ADDENDUM

ATTENTION ALL REQUEST FOR BID (RFB) HOLDERS
RFB NO. 316048 - ADDENDUM NO. 1

NEW RESTROOM FACILITY
HENRY VILAS ZOO

P100

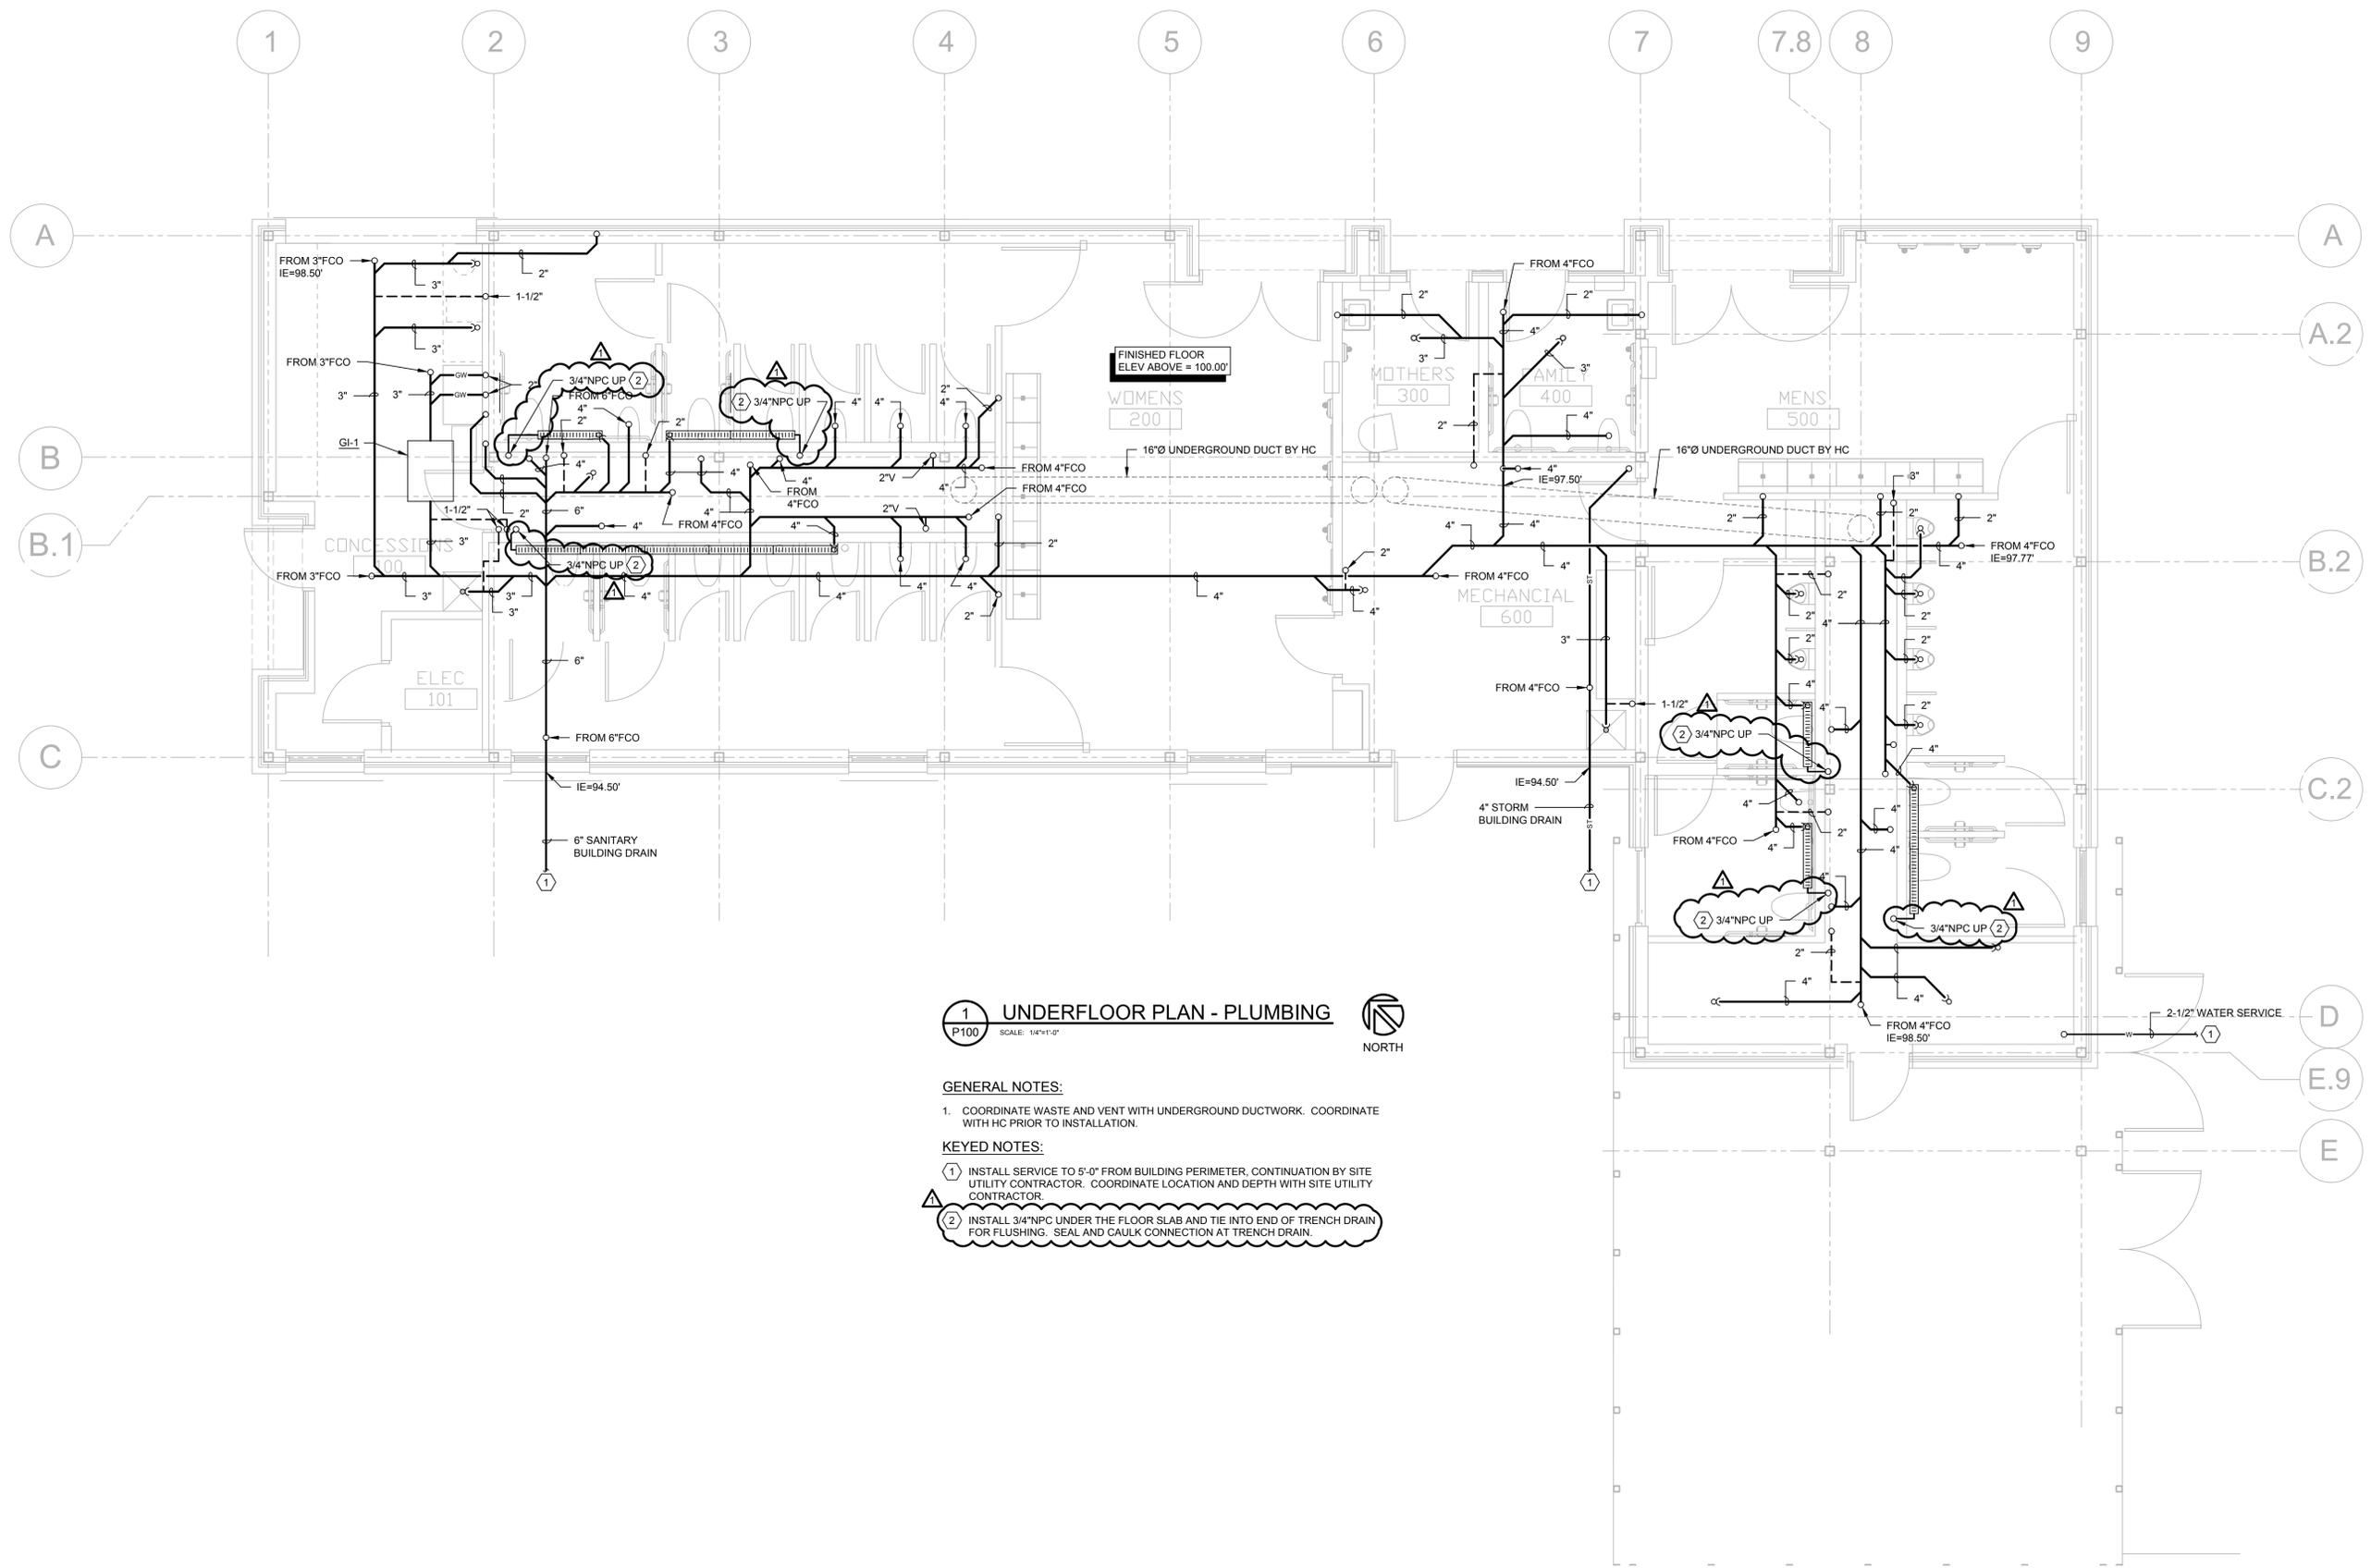
10. Sheet P100 - Underfloor Plan - Plumbing

- A. Replace Sheet P100 with new Sheet P100, issued with this Addendum
- B. Add non-potable cold water (NPC) connections to trench drains, attached.
- C. Add note #2, attached.

- GENERAL NOTES:**
- COORDINATE WASTE AND VENT WITH UNDERGROUND DUCTWORK. COORDINATE WITH HC PRIOR TO INSTALLATION.
- KEYED NOTES:**
- INSTALL SERVICE TO 5'-0" FROM BUILDING PERIMETER, CONTINUATION BY SITE UTILITY CONTRACTOR. COORDINATE LOCATION AND DEPTH WITH SITE UTILITY CONTRACTOR.
 - INSTALL 3/4"NPC UNDER THE FLOOR SLAB AND TIE INTO END OF TRENCH DRAIN FOR FLUSHING. SEAL AND CAULK CONNECTION AT TRENCH DRAIN.

P101

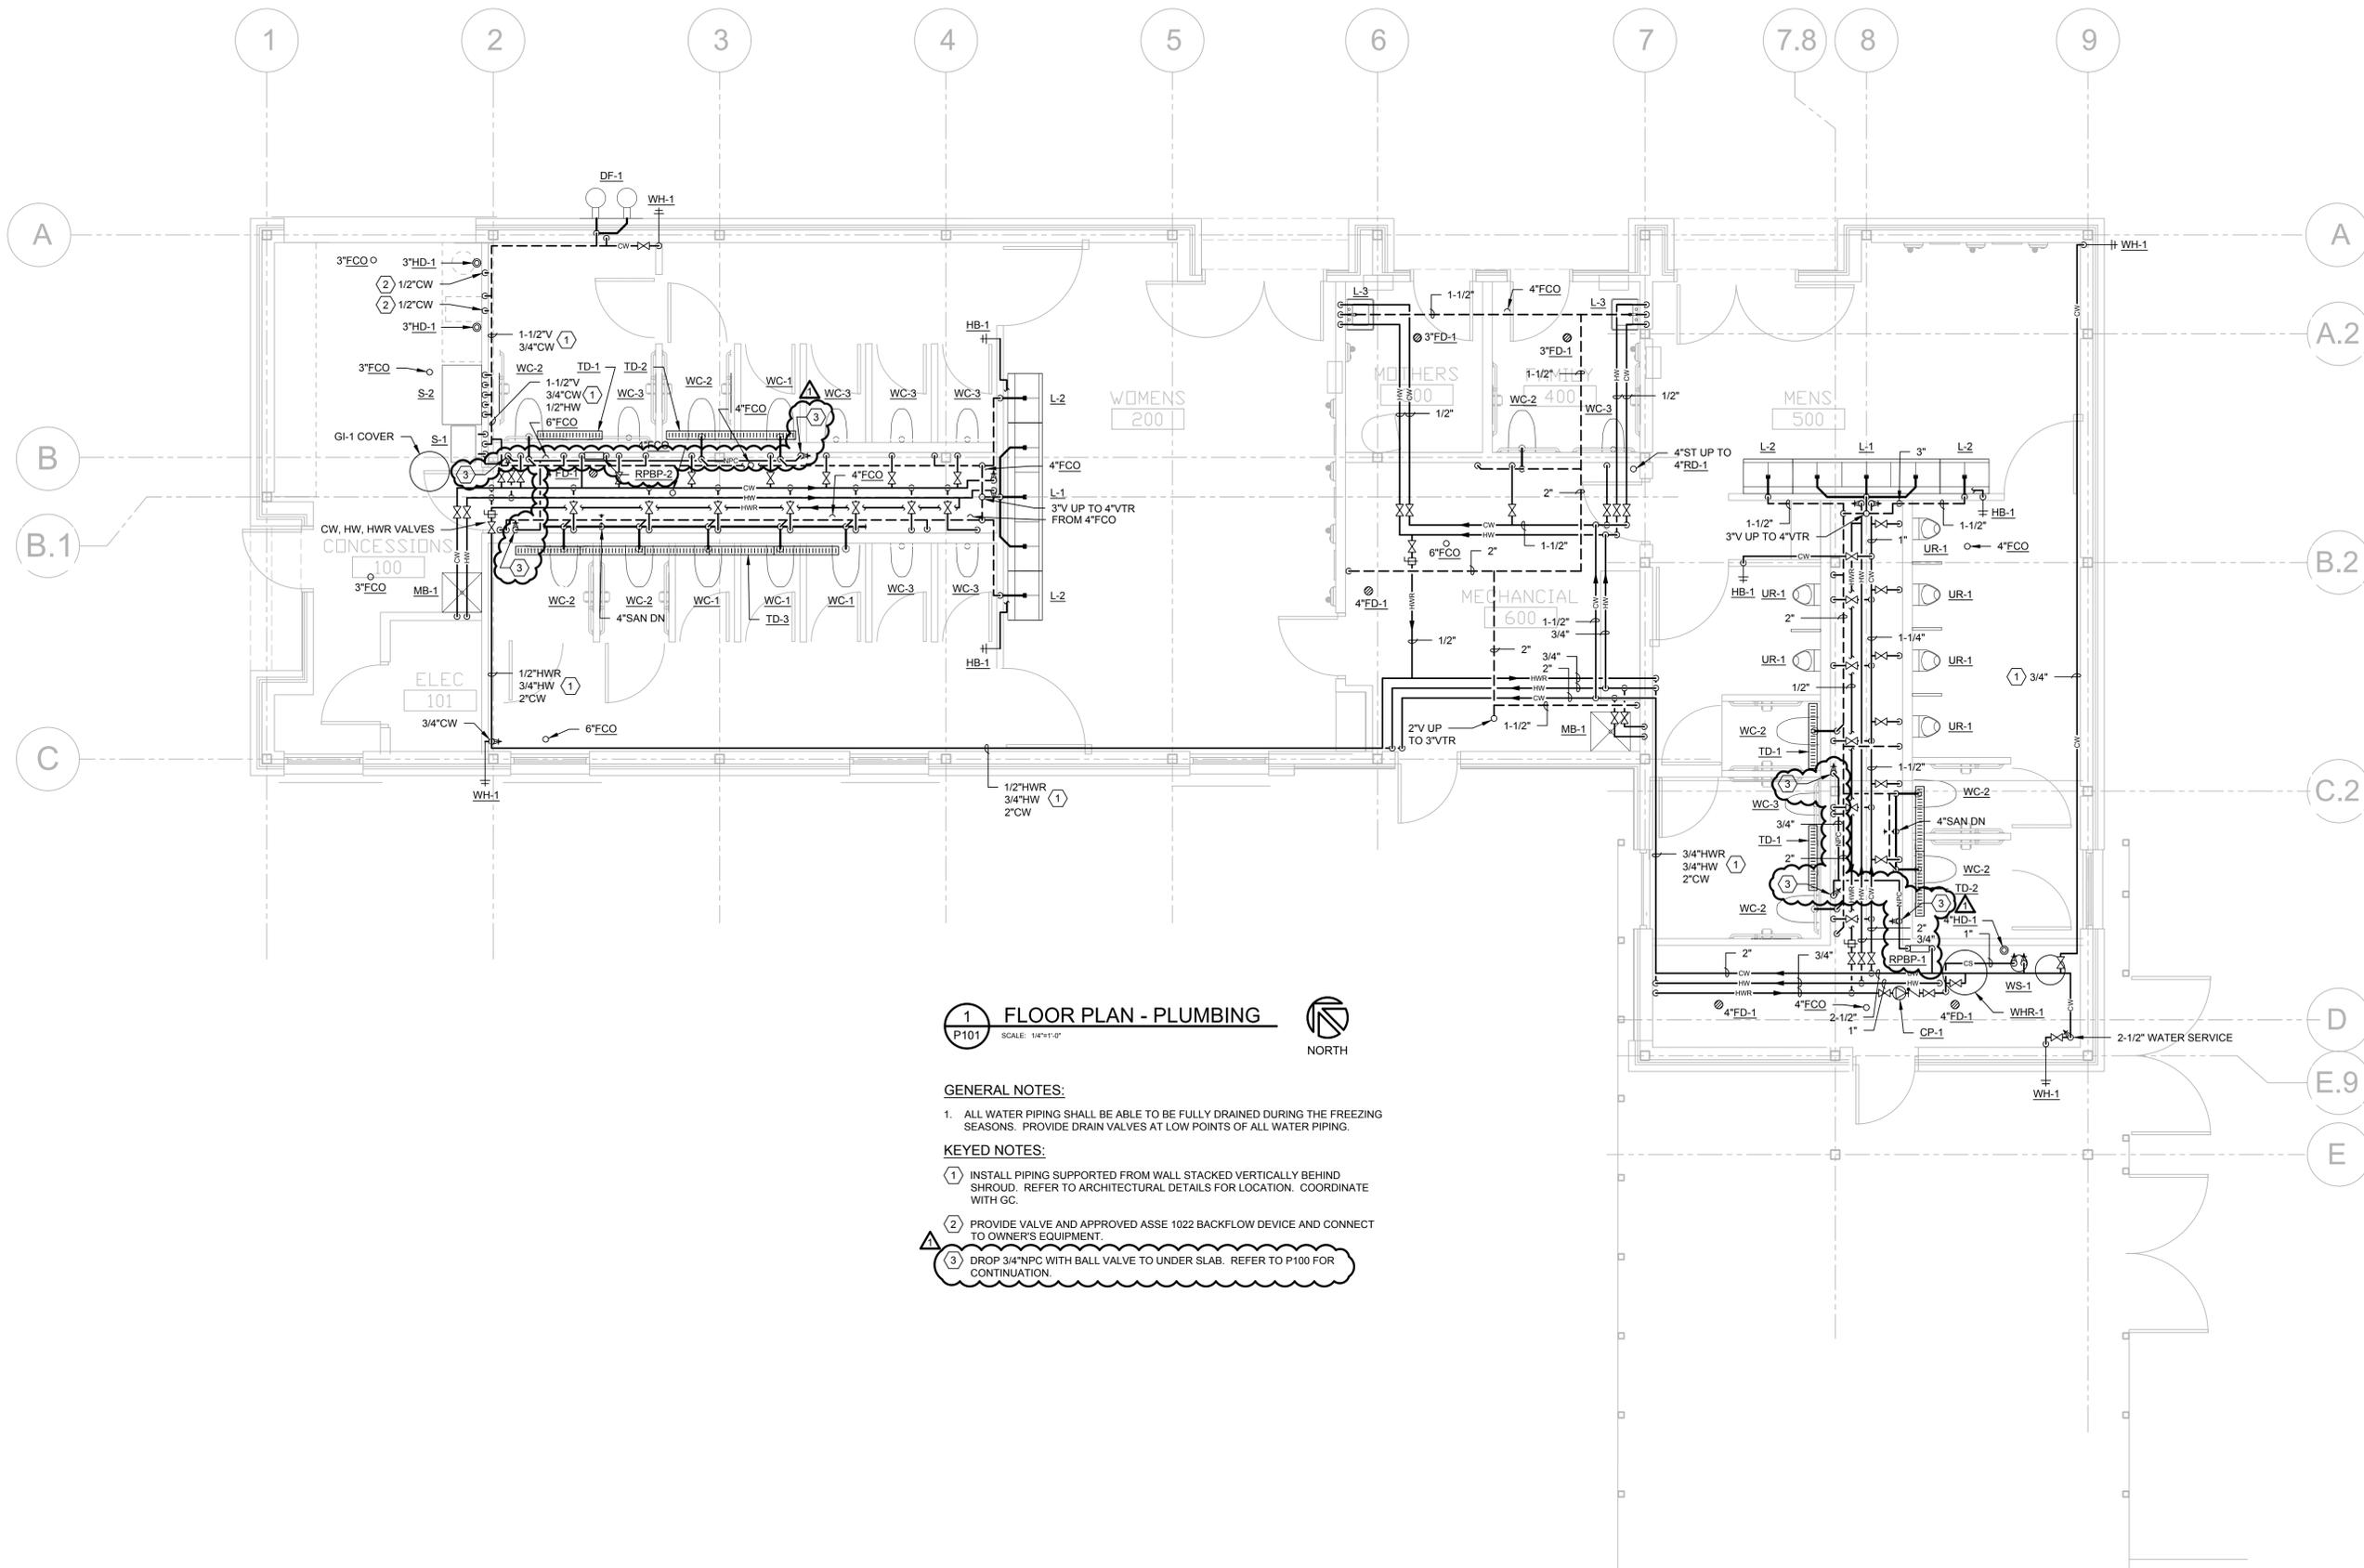
11. Sheet P101 – Floor Plan – Plumbing

- A. Replace Sheet P101 with new Sheet P101, issued with this Addendum.
- B. Add RPBP-1, RPBP-2, and piping for non-potable cold water (NPC) connections to trench drains, attached.
- C. Add note #3, attached.

1. INSTALL PIPING SUPPORTED FROM WALL STACKED VERTICALLY BEHIND SHROUD. REFER TO ARCHITECTURAL DETAILS FOR LOCATION. COORDINATE WITH GC.
2. PROVIDE VALVE AND APPROVED ASSE 1022 BACKFLOW DEVICE AND CONNECT TO OWNER'S EQUIPMENT.
3. DROP 3/4\"/>
